RUSSIAN FEDERATION
MINISTRY OF TRANSPORT OF THE RUSSIAN FEDERATION
FEDERAL AIR TRANSPORT AGENCY
AIRWORTHINESS DIRECTIVE

No. 2023-AHCAT, AHCAT-CK-03

Applicability – ANSAT helicopters (ANSAT, ANSAT-GC models) and their modifications

TECHNICAL DECISION No. 1/144-2023-KB3
on continued airworthiness of the ANSAT helicopters (ANSAT, ANSAT-GC models)

Fig. 1 TR blade

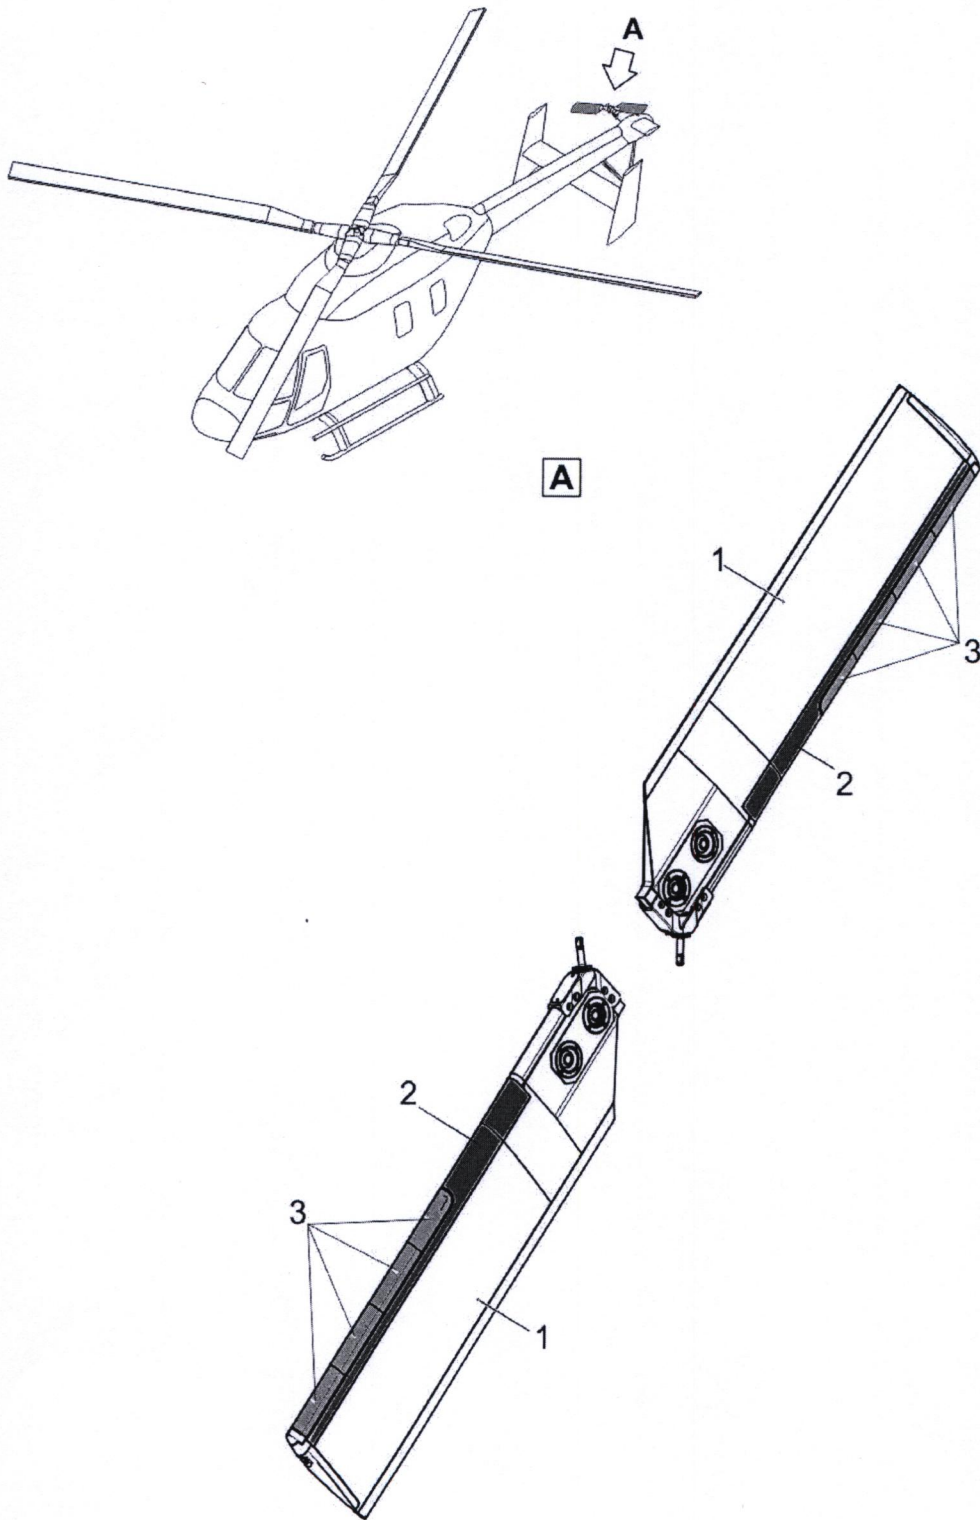
1. When carrying out periodic technical maintenance within the scope of "50 flight hours // 12 calendar months" maintenance form, additionally check for the absence of non-glueing of the strips 333.3950.1200 and blade edge tippings 333.3950.1203-03(05) (pos. 2 and 3, Fig. 1, Appendix 1) of the tail rotor blades 333.3950.1000 according to the temporary task card 064.10.00k (Appendix 2), at that, in case of detection of non-glueing, the tail rotor should be removed from operation and sent to JSC "Kazan Helicopters" to eliminate the defect.

Figure 201 – The template of the chart of non-glueing and dents on the tail rotor blade (to be completed when non-glueing and dents are detected).

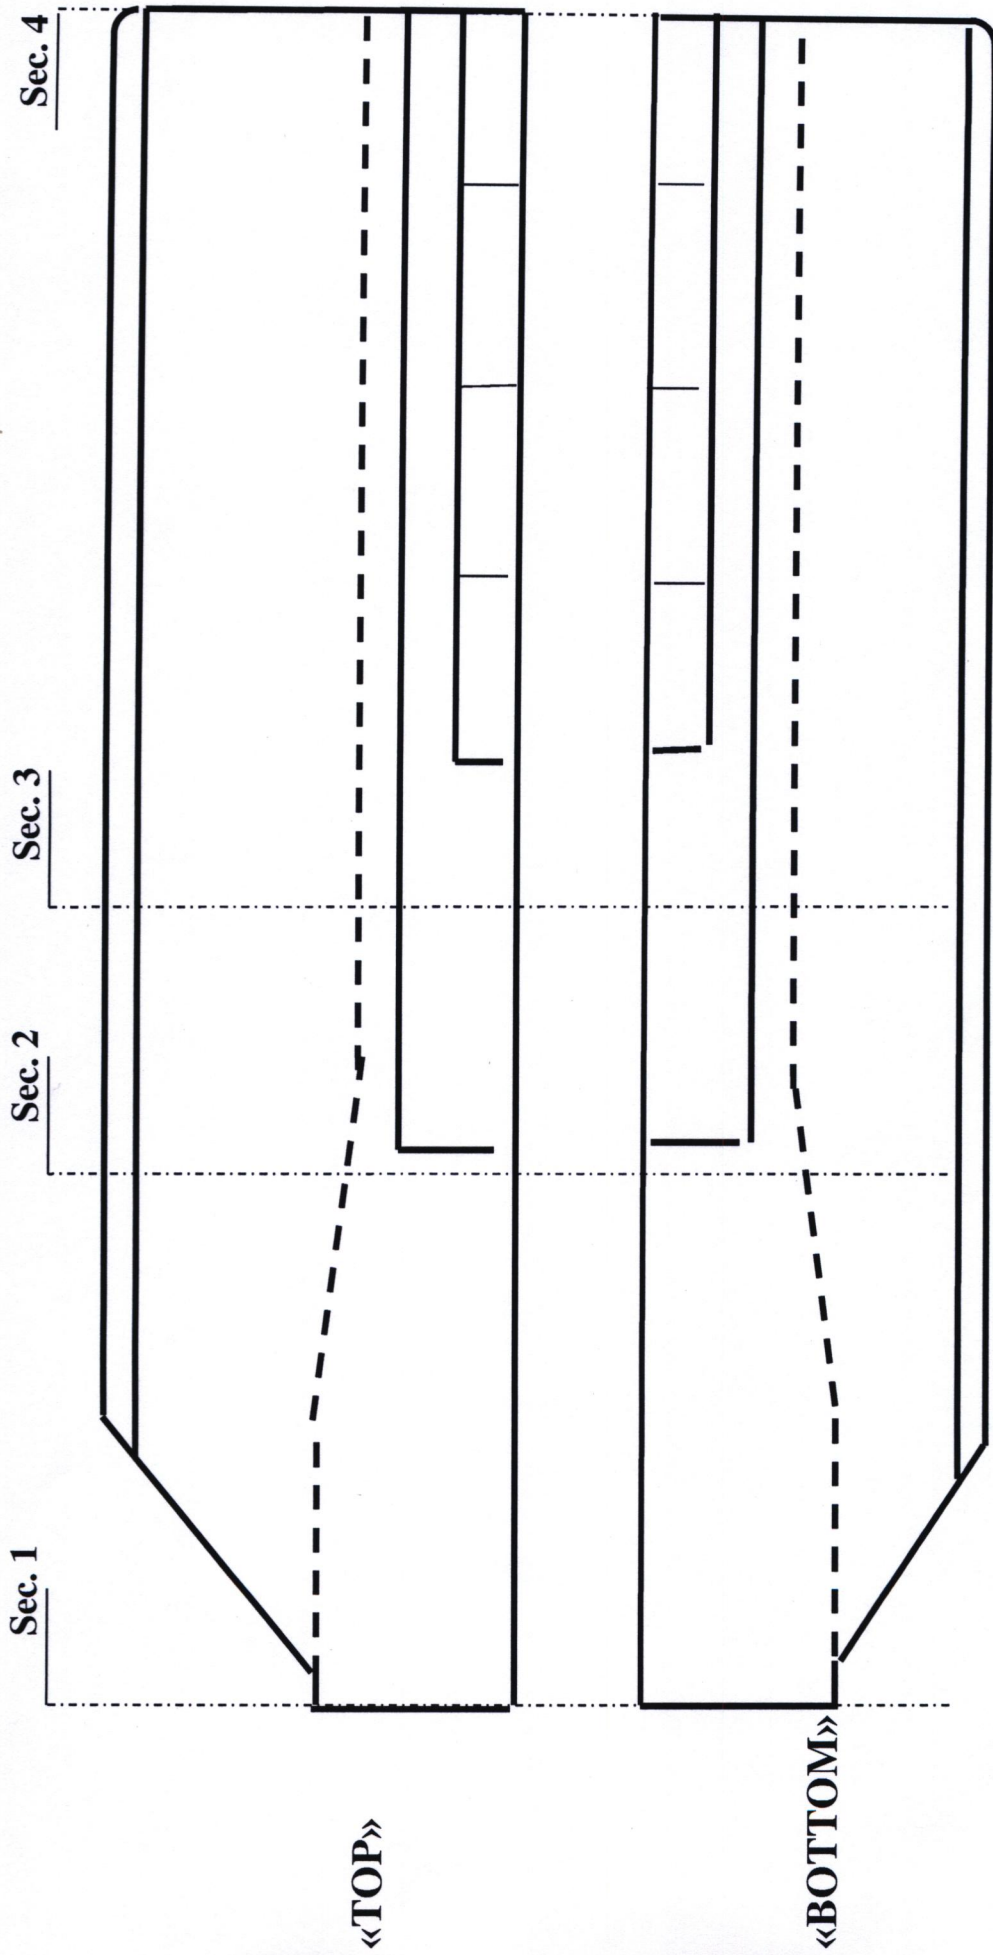
Temporary task card 064.10.00к	
Procedure: Control of condition of the strips and tail rotor blade edge tippings rubber layer and control of the absence of non-glueing	Corrective actions
Operations and technical requirements	
<ol style="list-style-type: none"> 1 Work is allowed to be carried out without removing the tail rotor blades from the helicopter. 2 Clean the tail rotor blades according to TC No. 064.10.00c. <p align="center">ATTENTION. WIPE THE TAIL ROTOR BLADES DRY BEFORE PERFORMING THE FOLLOWING OPERATIONS.</p> <ol style="list-style-type: none"> 3 Check the absence of non-glueing of rubber layer of the strips and tail rotor blade edge tippings by tapping with a duralumin hammer, proceeding as follows: <ul style="list-style-type: none"> - tap the entire rubber area of the strips and blade edge tippings with a free fall of the duralumin hammer from a height of no more than 10 ... 15 mm or with soft blows from a distance of no more than 10 mm, avoiding traces of tapping. Violation of glueing is characterized by a change in tone; - if any defects are detected, fill in the chart of non-glueing and dents (see Figure 201), make marks on the tail rotor blades with a soft pencil. <p>The presence of non-glueing is not allowed.</p> 4 Perform a visual check of the condition of the rubber layer of the tail rotor blade strips for the absence of damage. Crumbling of the rubber layer with a total area of no more than 10 cm² with the size of a single crumbling with an area of no more than 2.5 cm² and a width of no more than 0.5 cm is allowed.
